Technical Service Bulletin

**MODEL(S)
AFFECTED:****Speed Scrub Rider**

Potential squeegee lift actuator and/or spring housing failure due to a clearance issue.

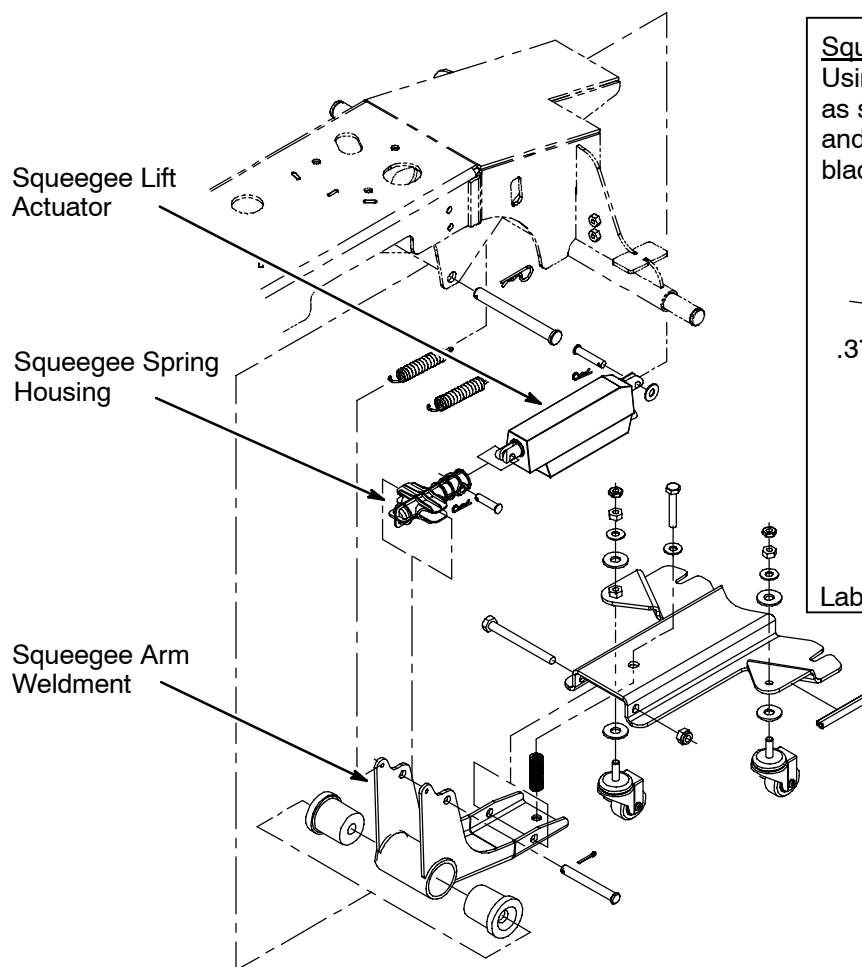
To prevent potential actuator and spring housing failure, the squeegee arm weldment must be modified as described below. The suggested modification will provide proper clearance for actuator movement, eliminating the risk for failure.

Squeegee Arm Weldment Modification:
Using a die-grinder, remove the material as shown. Blow out the metal shavings and touch up the exposed metal with black paint.
